CITY OF MANZANITA Manzanita Classic Street Connection Project Addendum Number 2

DATE: May 7, 2025

ENGINEERING PLANS - ADDENDUM 2

GRADING PLAN

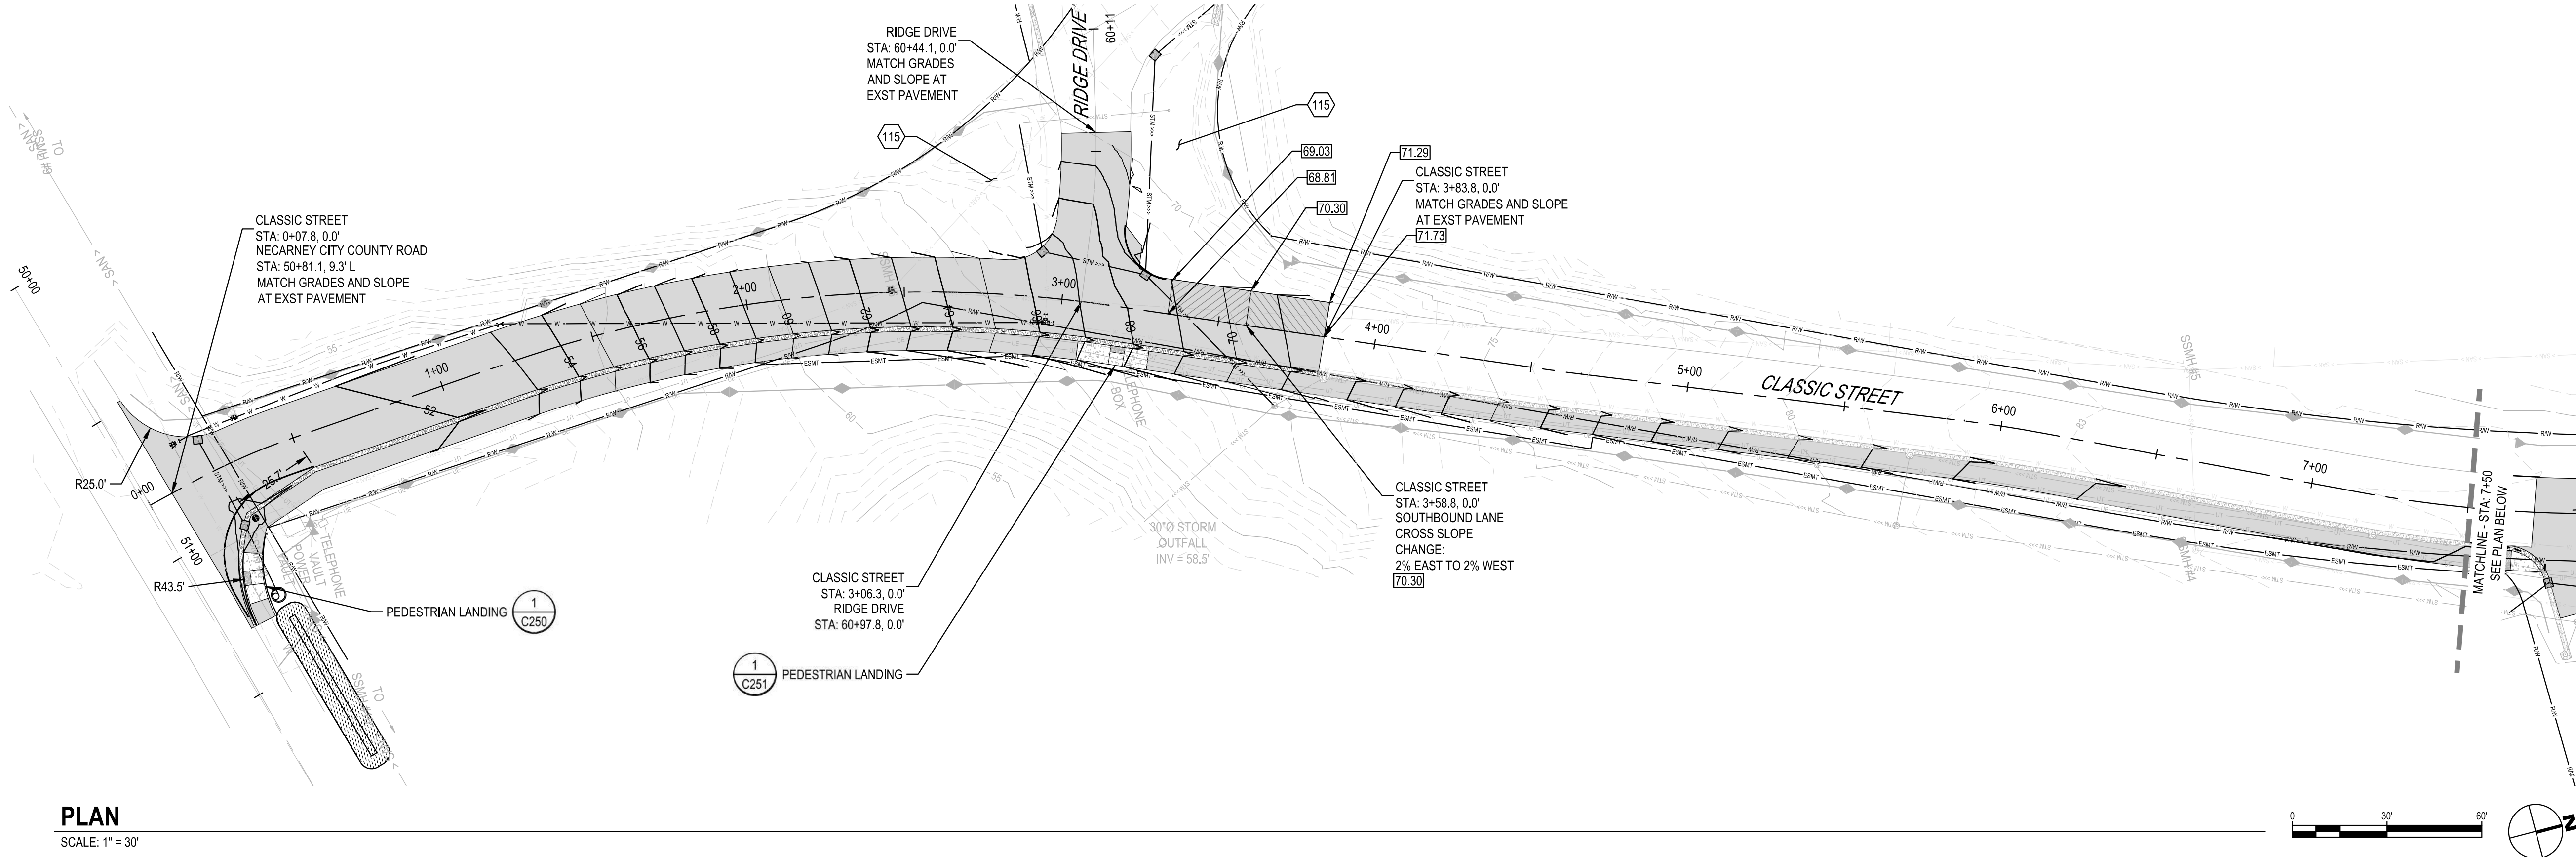
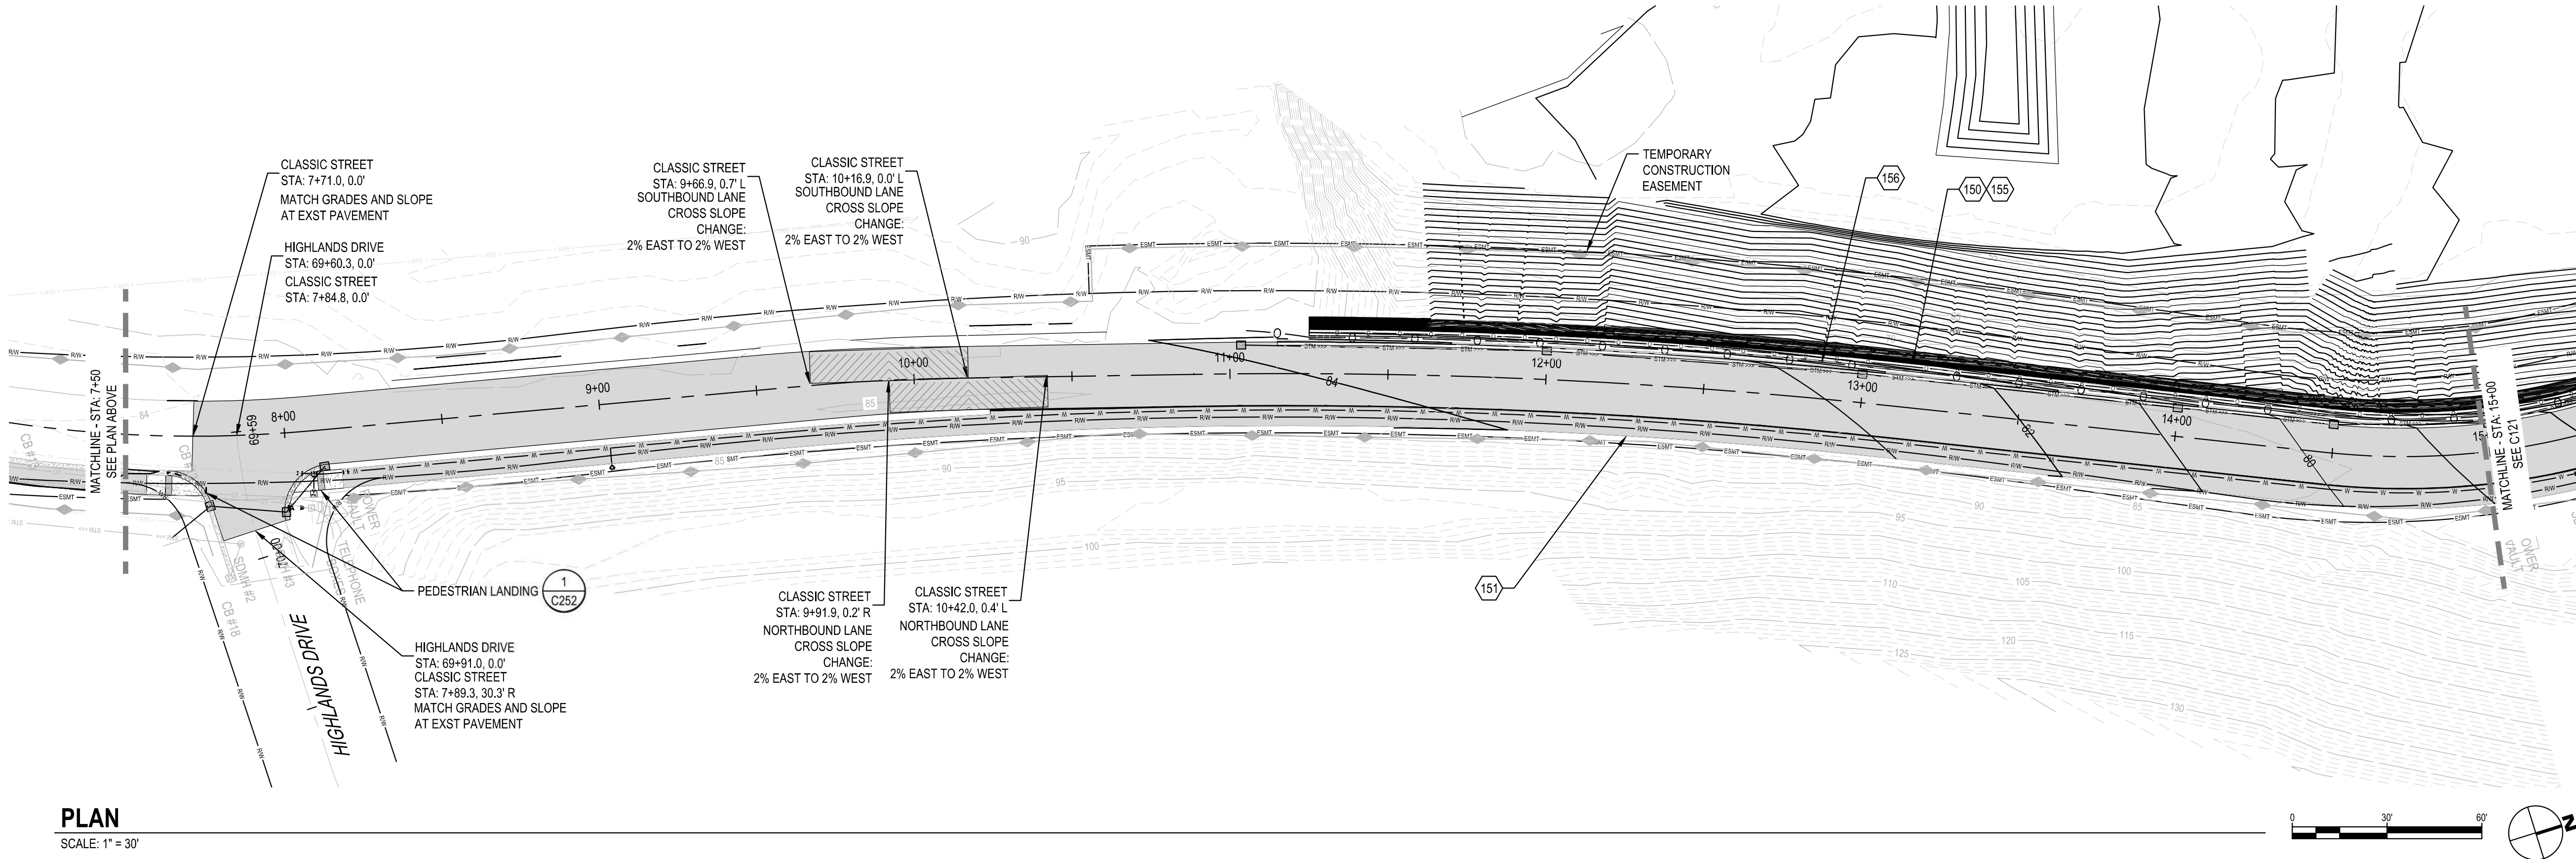
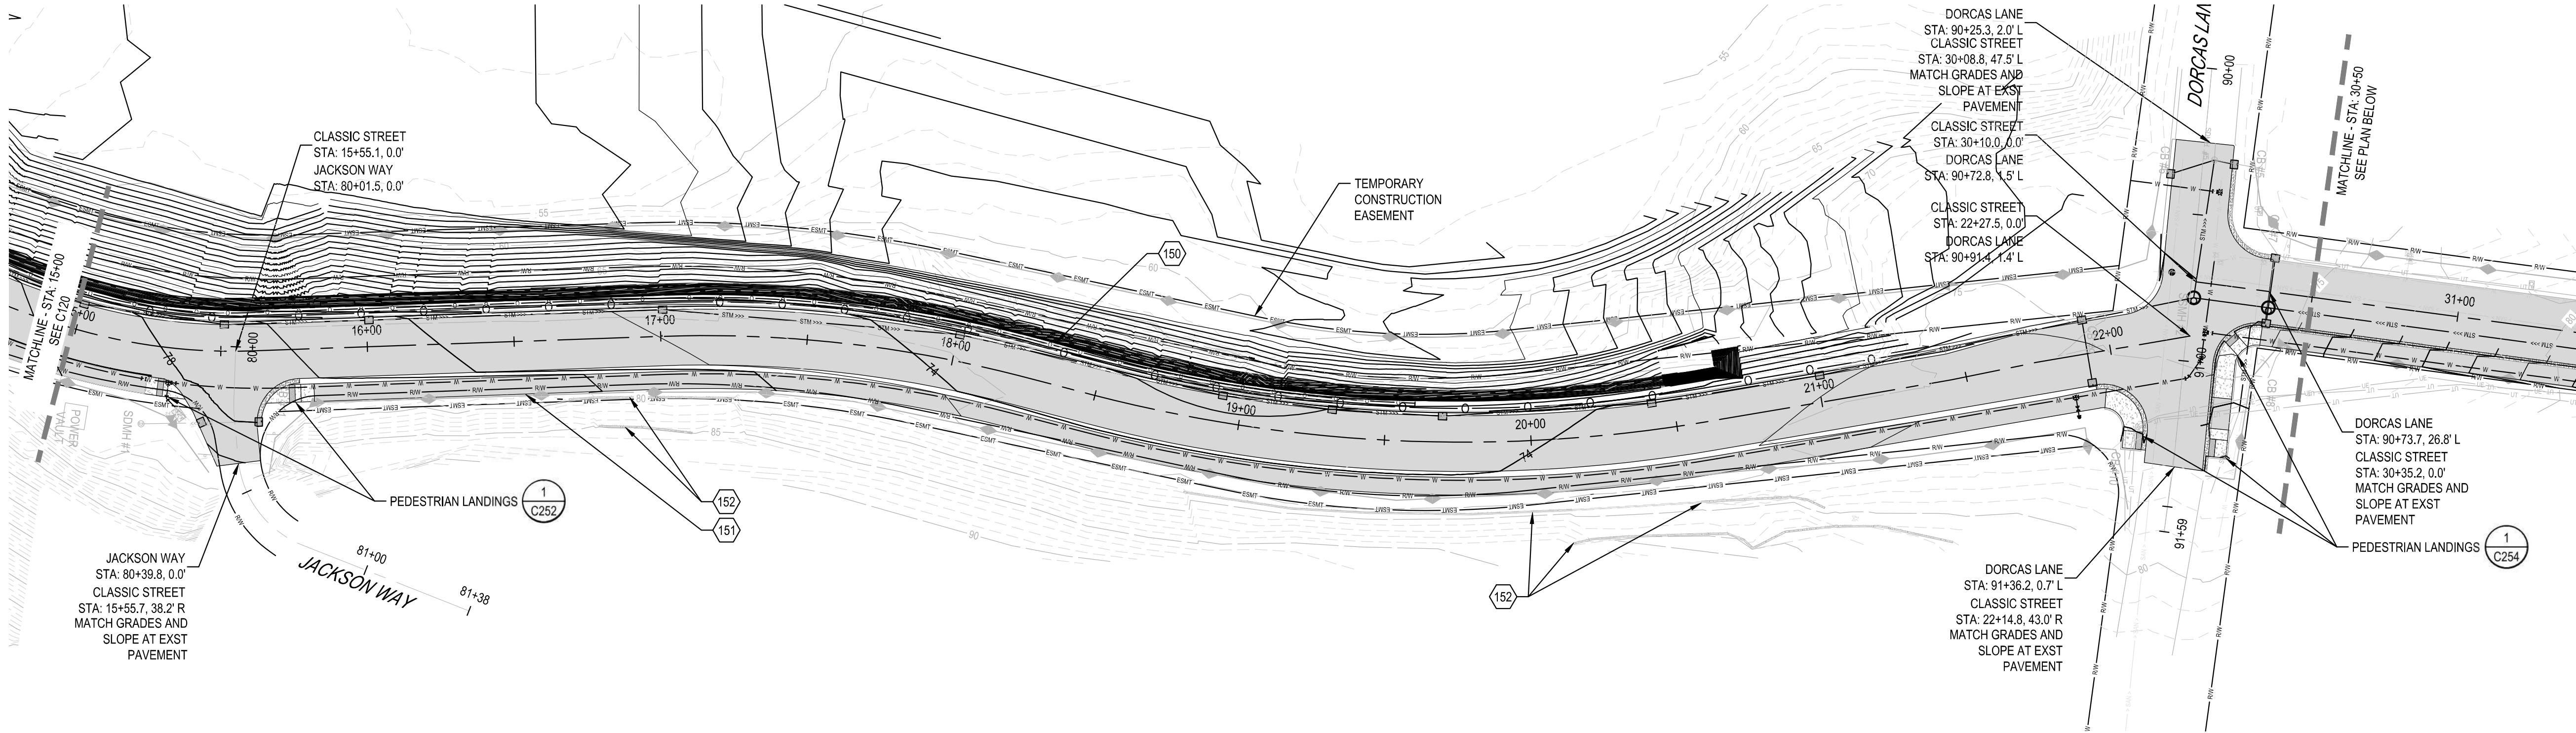
- **G001** – Cover: Updated project name and sheet index.
 - **C120, C120** – Grading Plan: Proposed contours updated to include development proposed contours to show how grading tie-ins work along the retaining wall, approximately from Sta 11+00 to 22+00.

ROAD AND UTILITY PLAN AND PROFILE

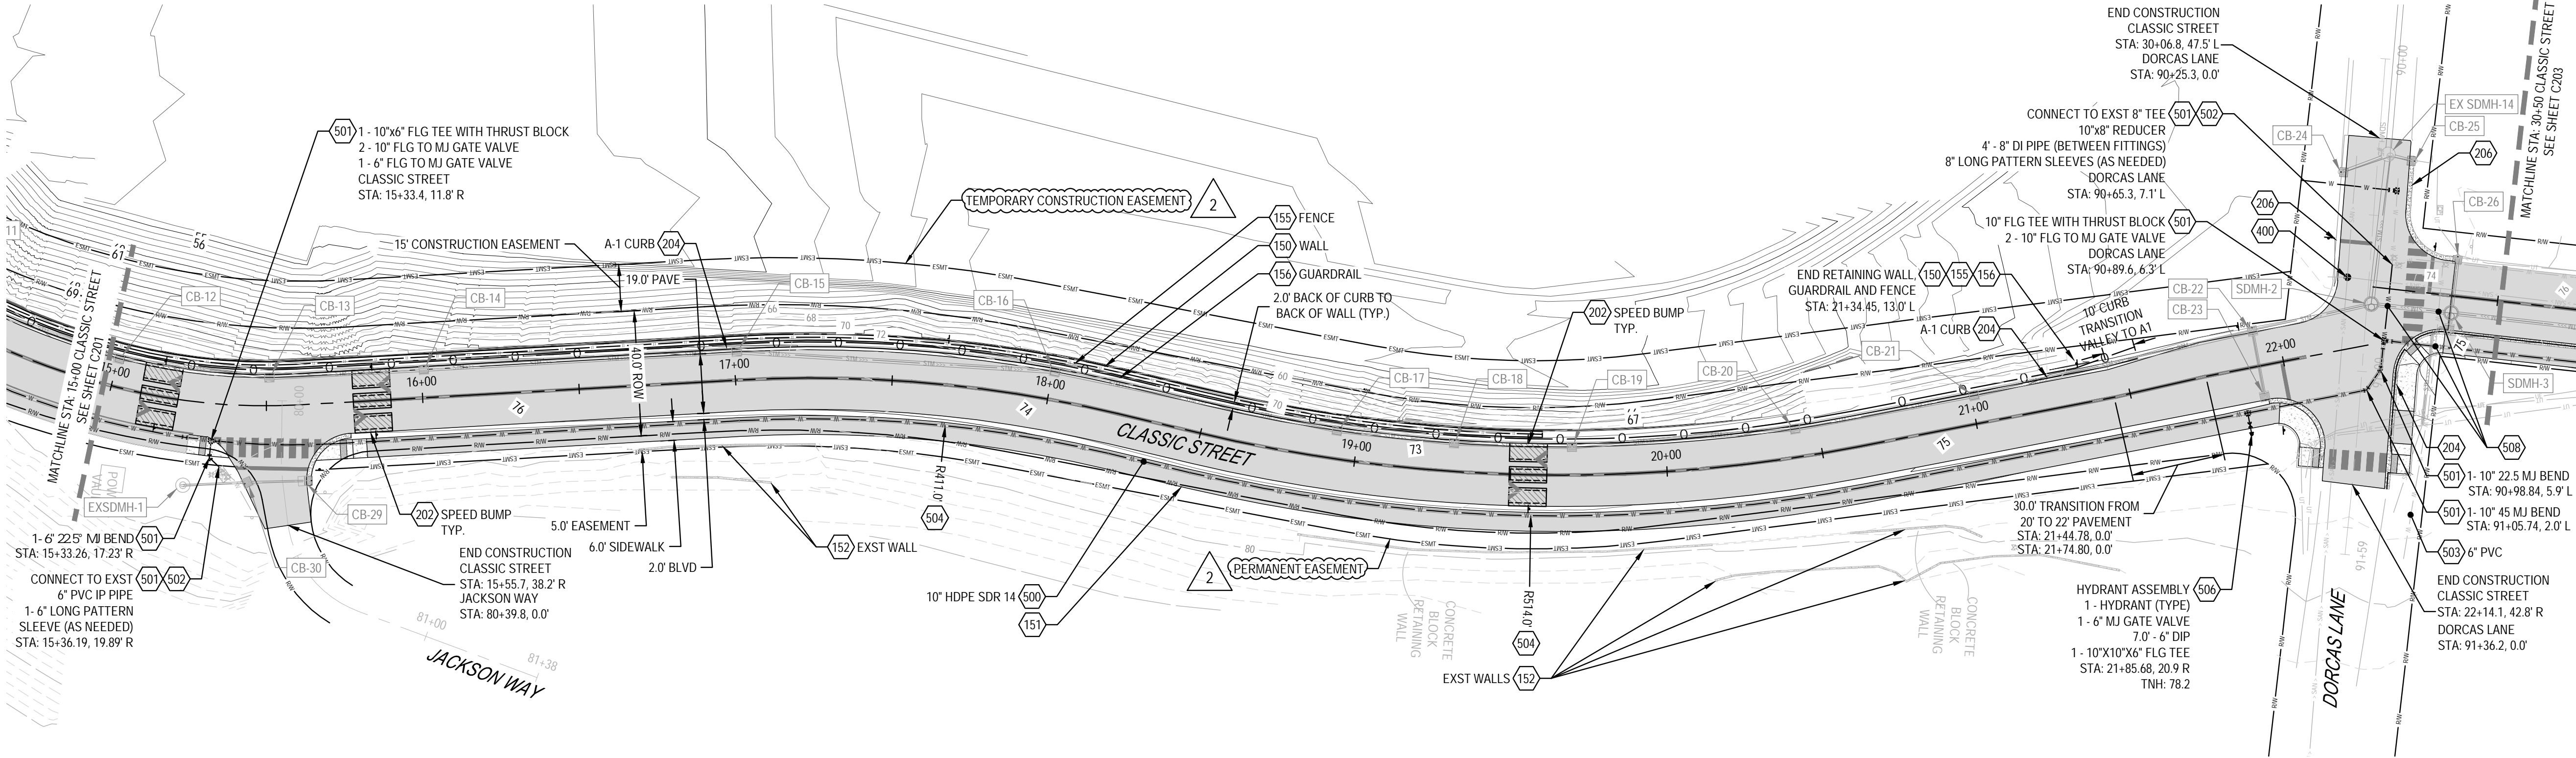
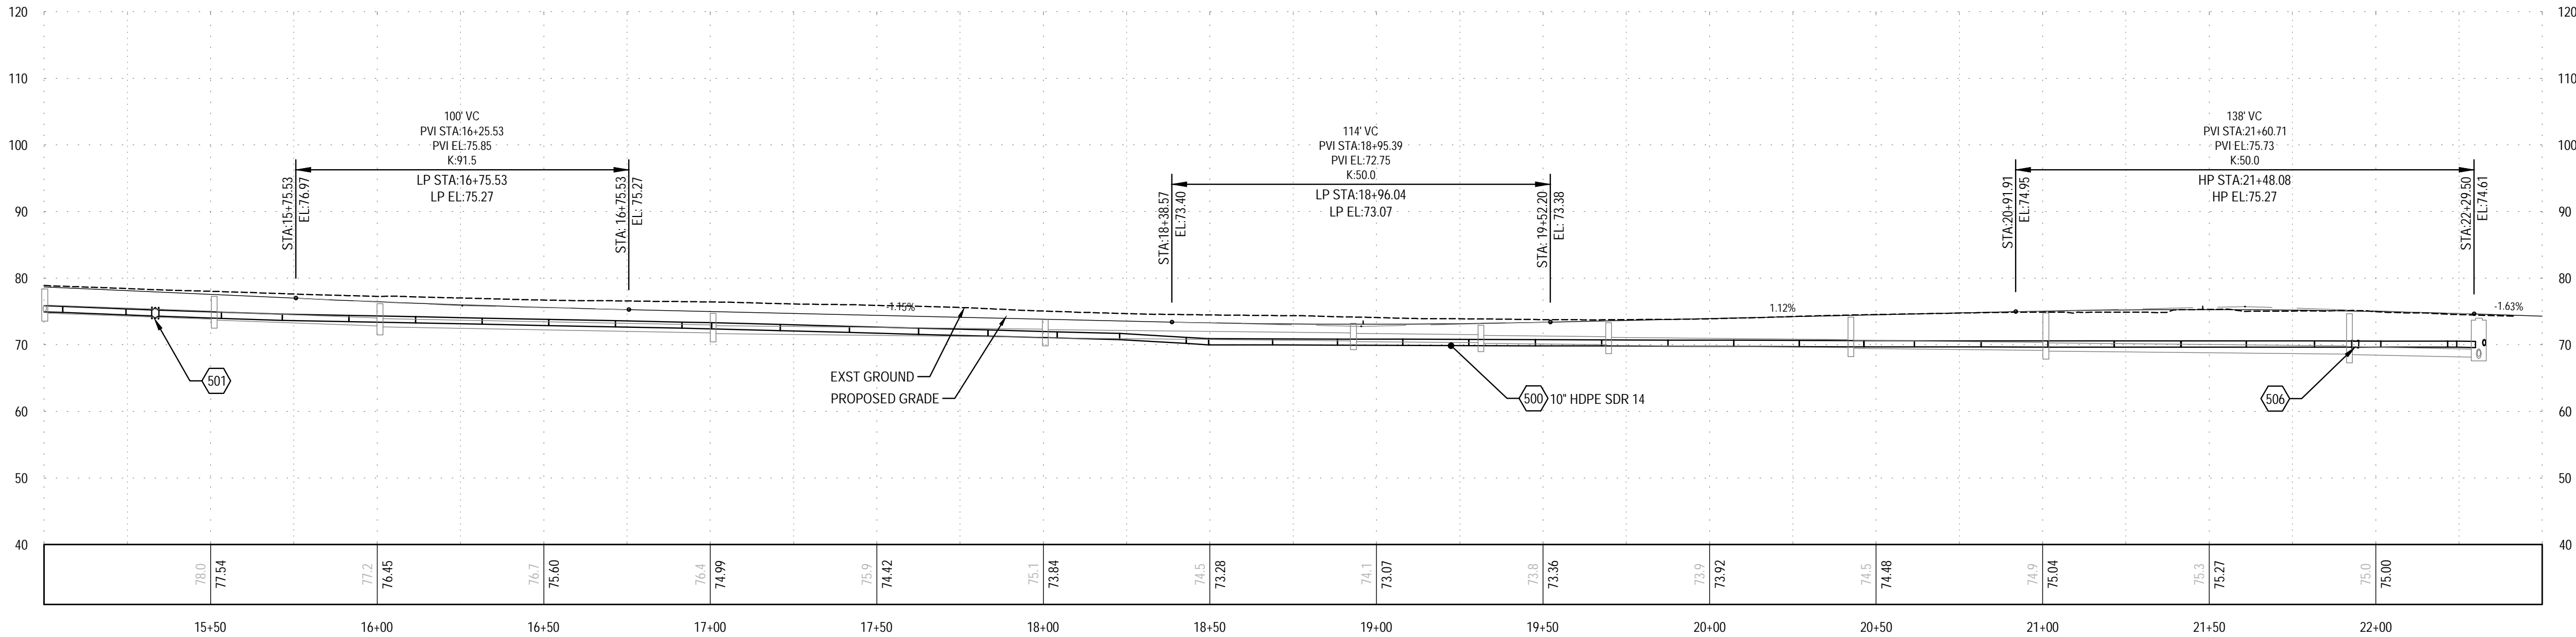
- **C201, C202** – Road and Utility Plan: Proposed contours updated to include development proposed contours to show how grading tie-ins work along the retaining wall, approximately from Sta 11+00 to 22+00. Call outs for “Temporary Construction Easement” and Permanent Easement.”
